National Committee on Uniform Traffic Control Devices

1
2 **National Committee on Uniform Traffic Control Devices (NCUTCD)**
3 **Recommended Changes to Proposed Text for 11th Edition of the MUTCD**
4 **Docket Number: FHWA-2020-0001**

5 **Federal Register Item Number:** 516

6 **NPA MUTCD Section Number:** Section 6P.01

Figure 6P-39. Median Crossover on a Freeway (TA-39)

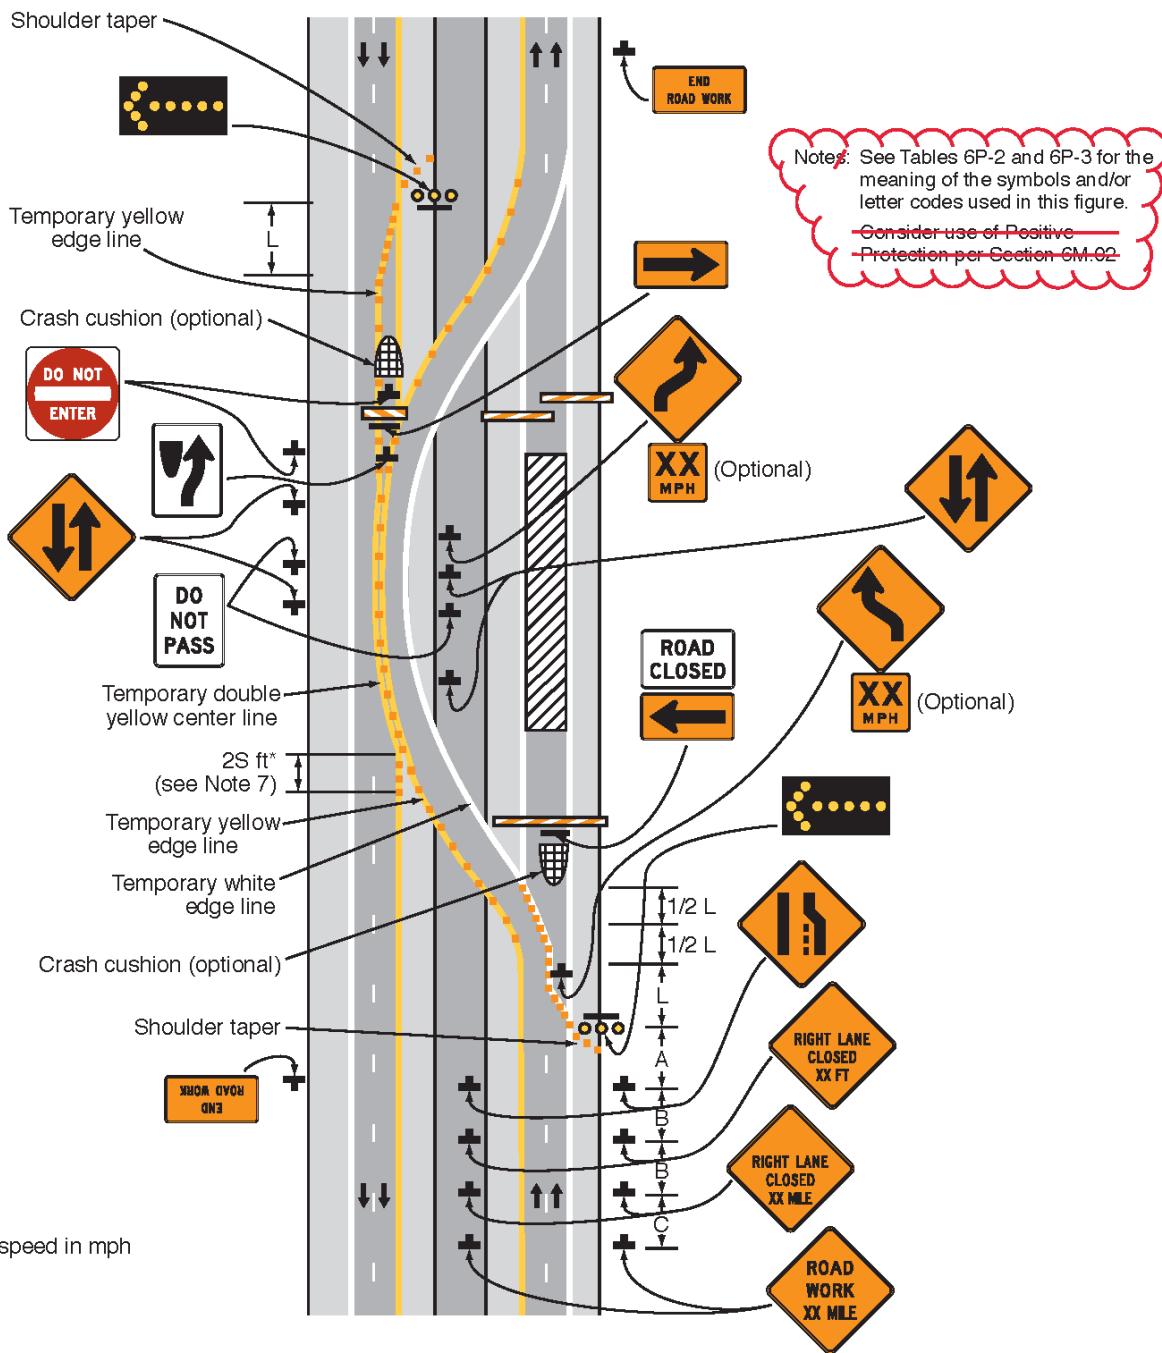
Figure 6P-39 Comments: NCUTCD generally agrees with Figure 6P-39 as presented in the NPA, but recommends deleting a new positive protection note in the typical application figure since it is redundant with a note added to the notes page.

Figure 6P-41. Median Crossover for an Exit Ramp (TA-41)

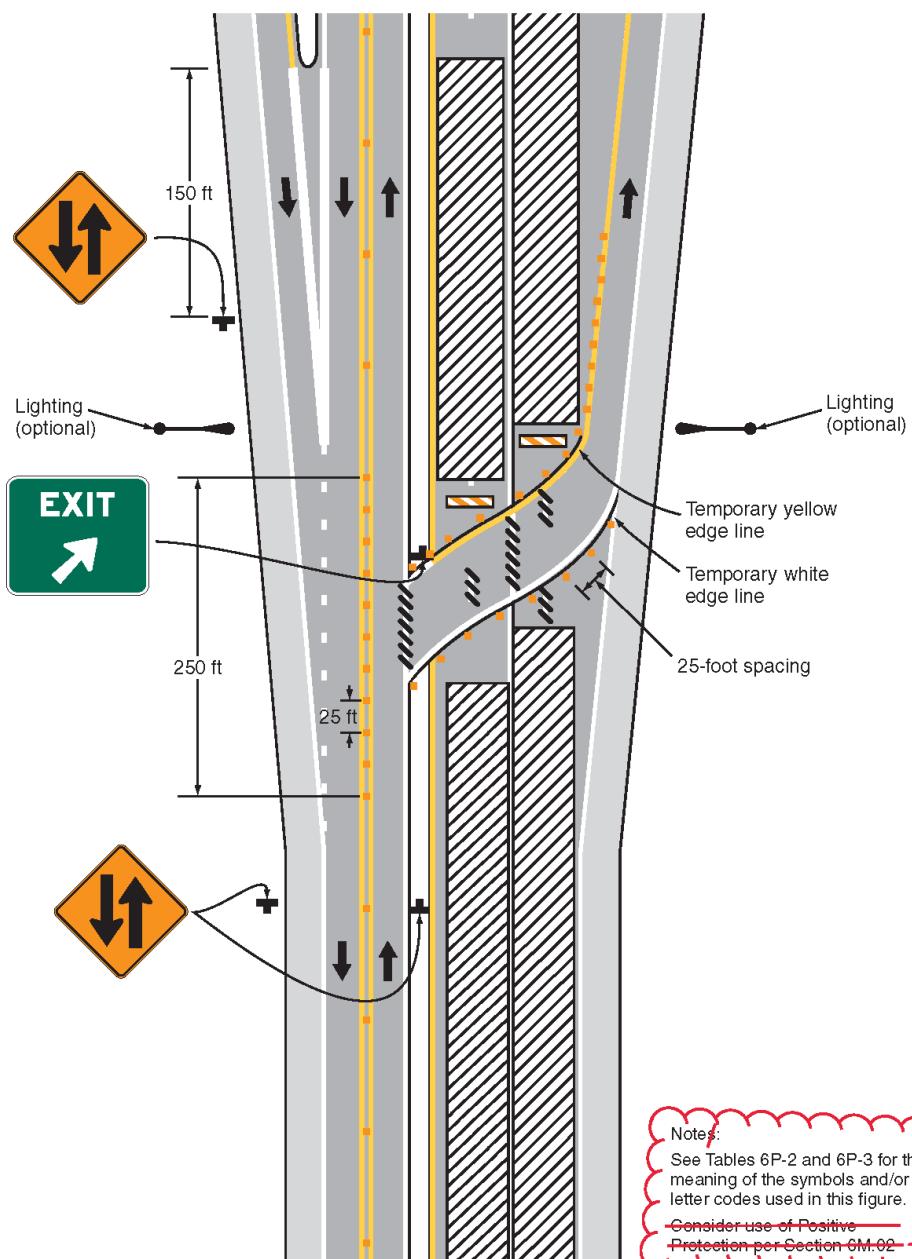
Figure 6P-41 Comments: NCUTCD generally agrees with Figure 6P-41 as presented in the NPA, but recommends deleting a new positive protection note in the typical application figure since it is redundant with a note added to the notes page.

Figure 6P-42. Work in the Vicinity of an Exit Ramp (TA-42)

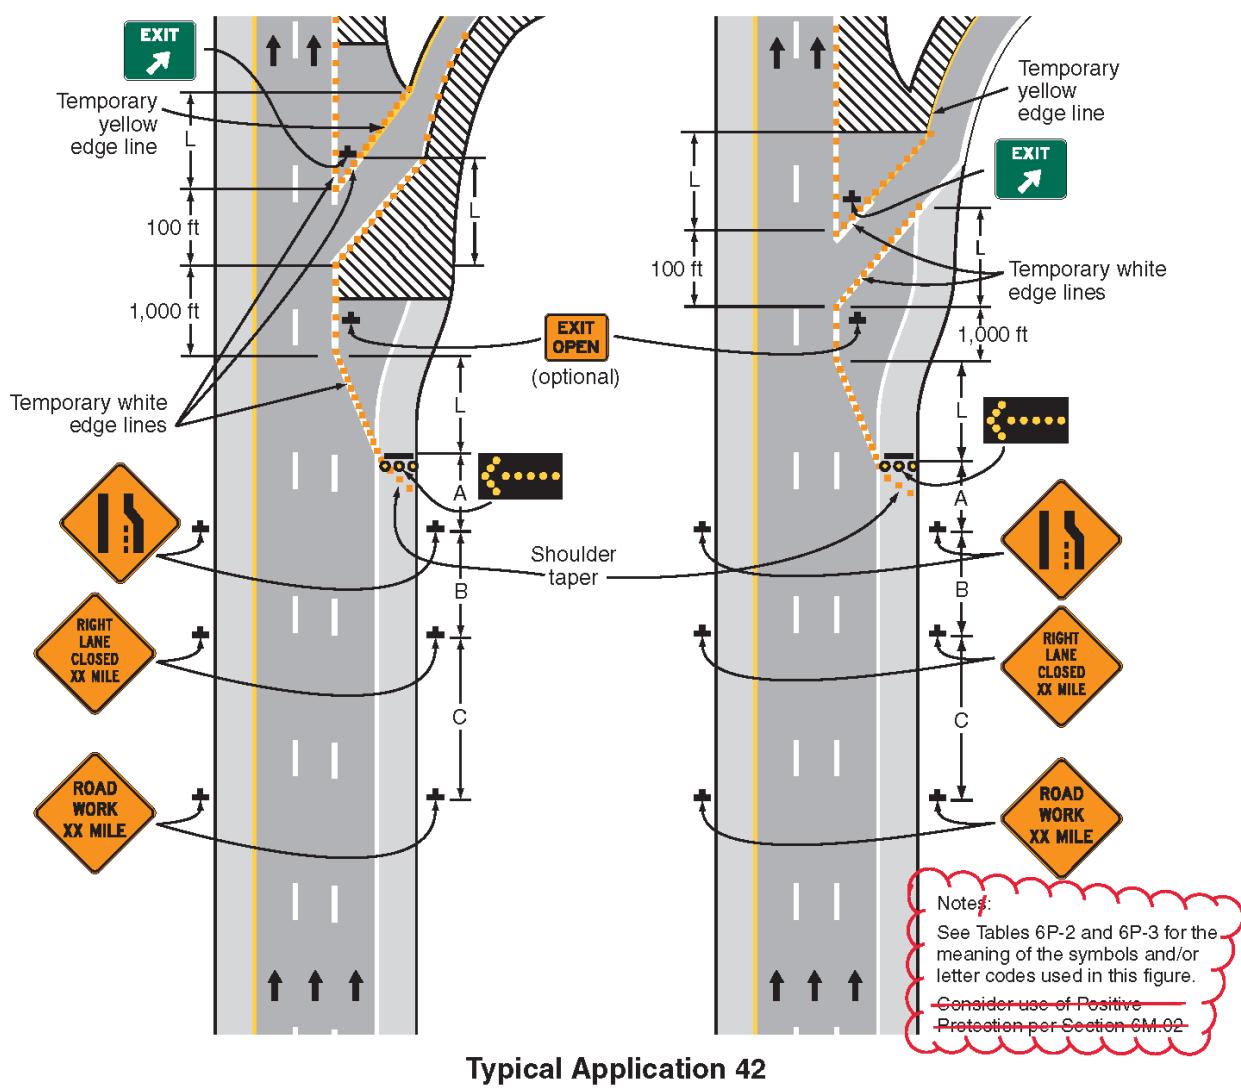
Figure 6P-42 Comments: NCUTCD generally agrees with Figure 6P-42 as presented in the NPA, but recommends deleting a new positive protection note in the typical application figure since it is redundant with a note added to the notes page.

Figure 6P-48. Bicycle Lane Closure with on-Road Detour (TA-48)

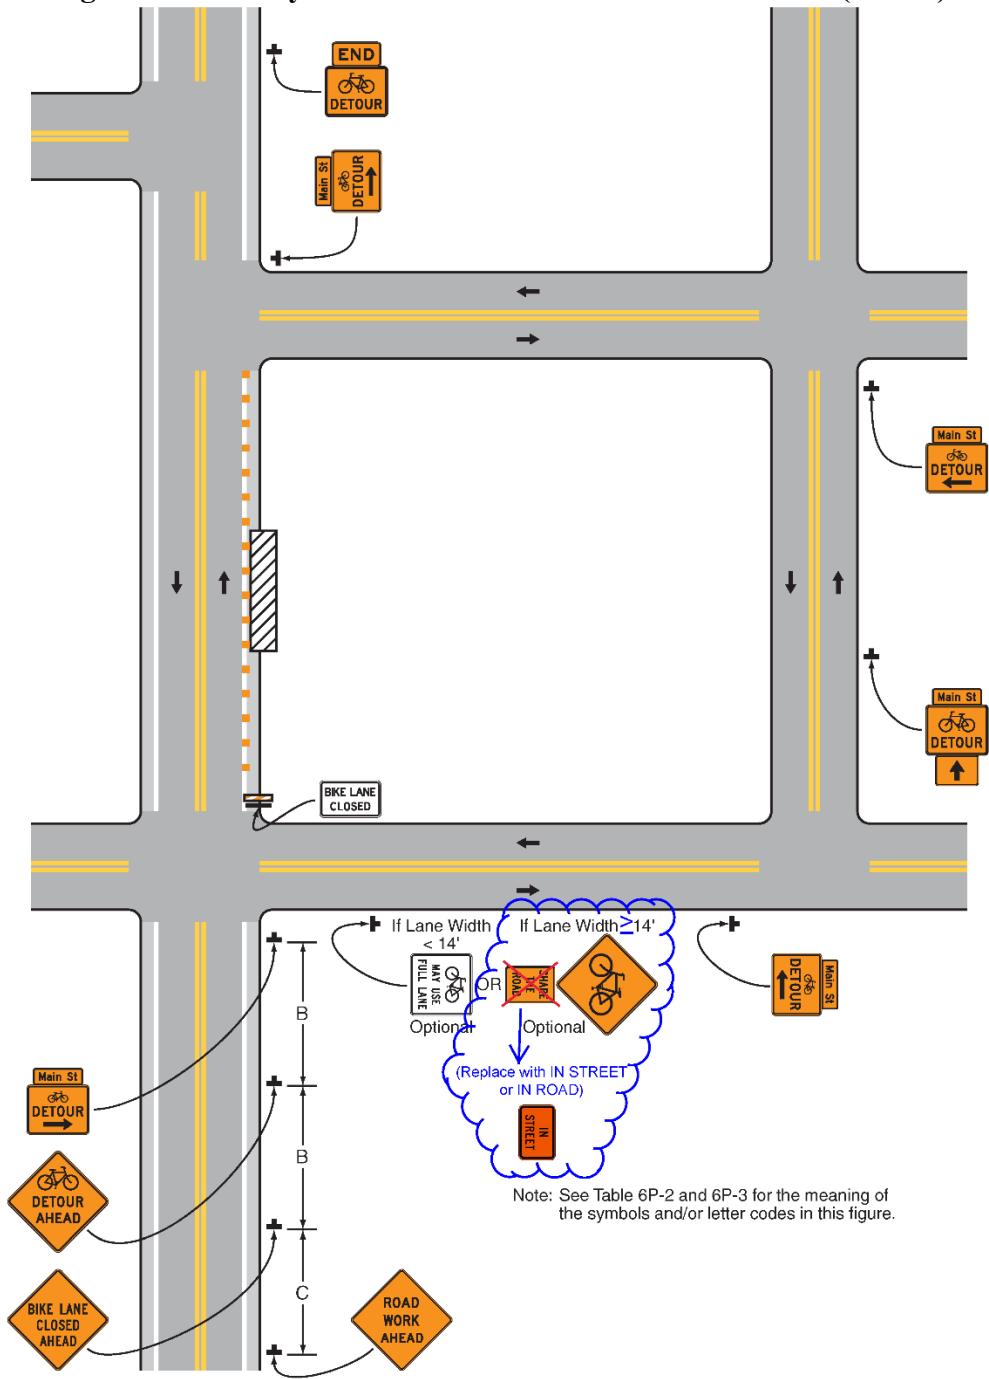
2225
2226
2227
2228
2229 **Figure 6P-48 Comments:** NCUTCD generally agrees with Figure 6P-48 as presented in the
NPA, but recommends changing the plaque to IN ROAD or IN STREET for consistency with
Chapter 2C.

Figure 6P-50. On-Road Detour for Shared-Use Path (TA-50)

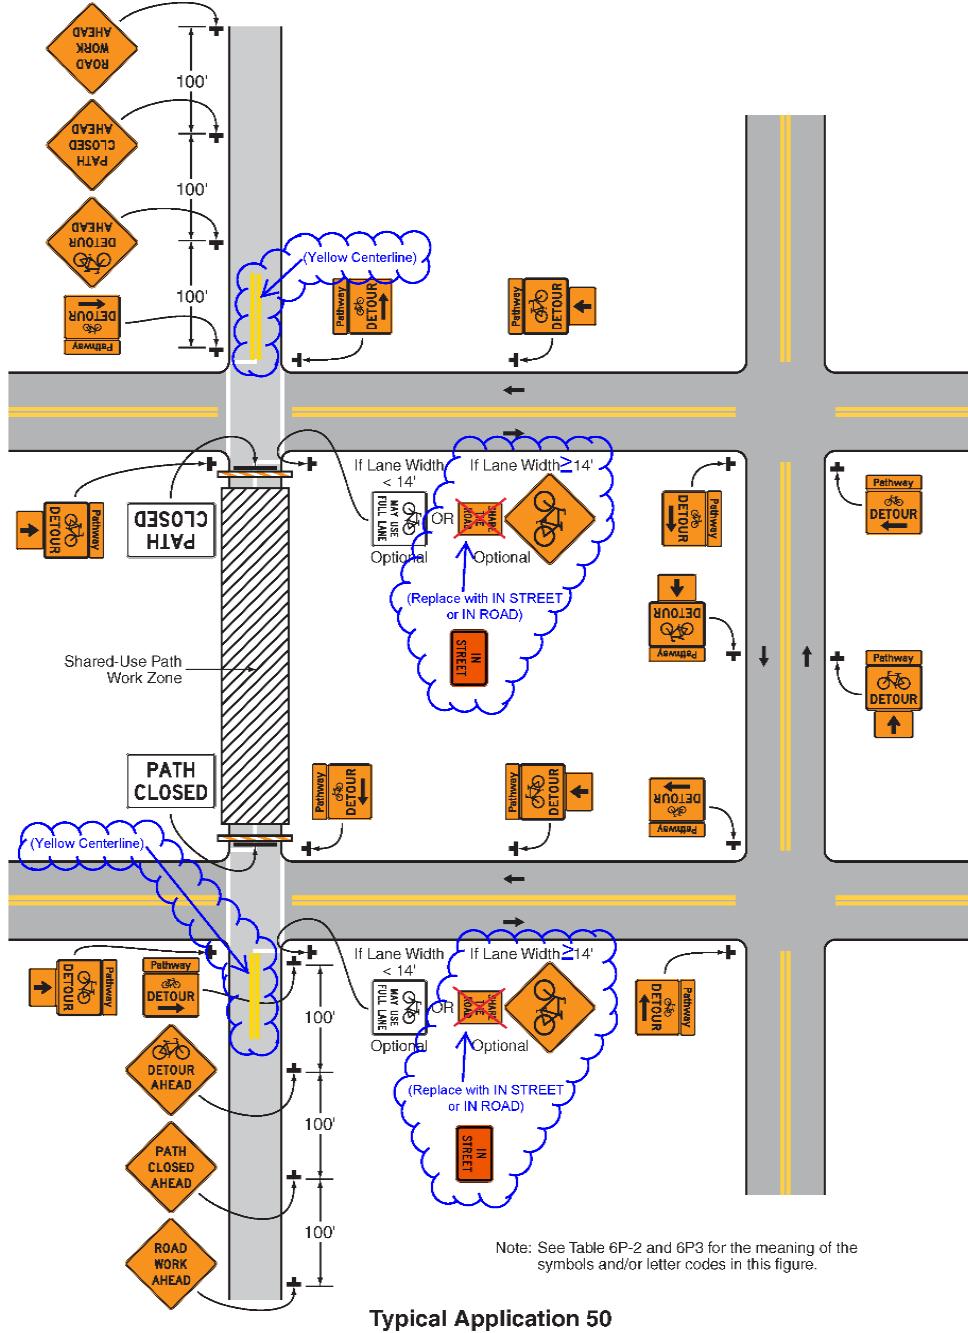
Figure 6P-50 Comments: NCUTCD generally agrees with Figure 6P-50 as presented in the NPA, but recommends changing the plaque to IN ROAD or IN STREET for consistency with Chapter 2C.

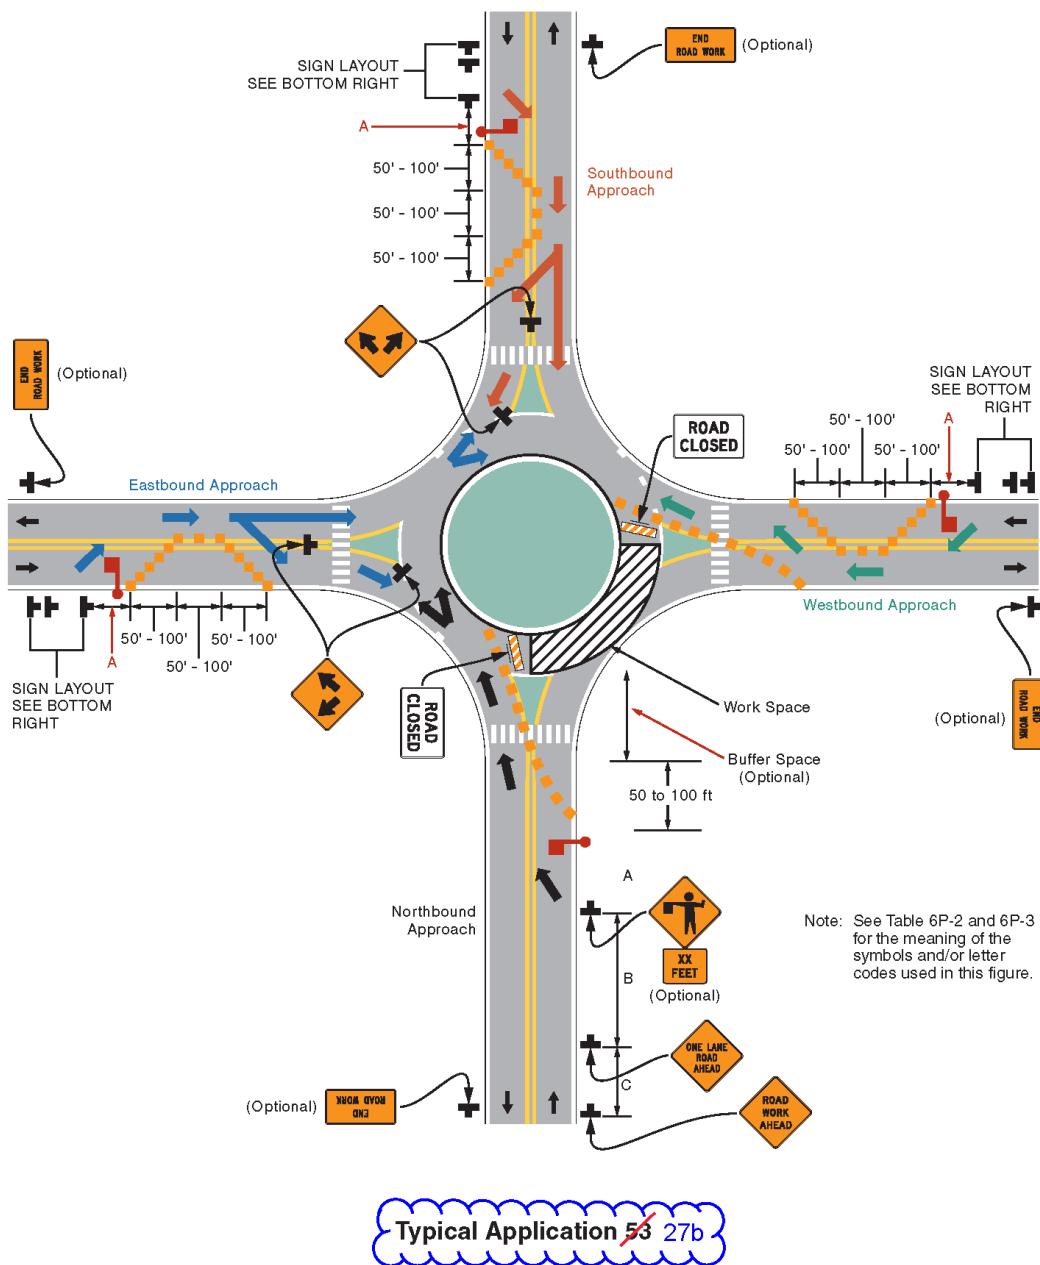
2386 **Figure 6P-53 Comments:** NCUTCD generally agrees with Figure 6P-53 as presented in the
2387 NPA, but recommends renumbering the typical application to 6P-27b and placing it between TA-
2388 27—Closure at the Side of an Intersection and TA-28—Sidewalk Detour or Diversion, since this
2389 typical application is intersection related.

Figure 6P-27d. Circulating Lane Closure in a Multi-Lane Roundabout (TA-27d)

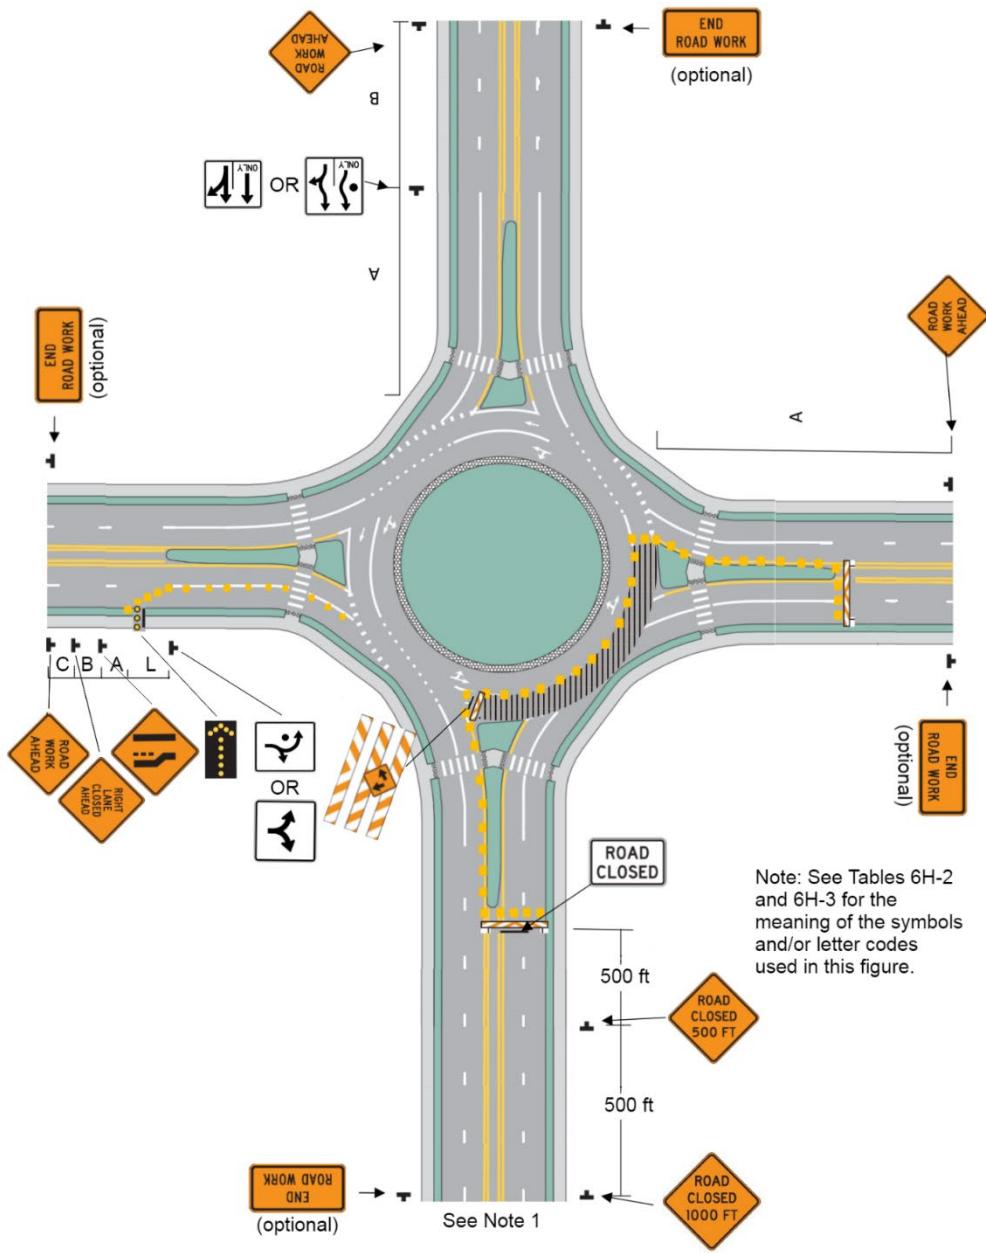
2479
2480
2481
2482
2483
Figure 6P-27d Comments: NCUTCD recommends adding a new Typical Application 27d
2484 titled "Circulating Lane Closure in a Multi-Lane Roundabout" in accordance with NCUTCD
2485 recommendation 19B-TTC-01, and placing the new typical application between TA-27—Closure
at the Side of an Intersection and TA-28—Sidewalk Detour or Diversion since the typical
application is intersection related.
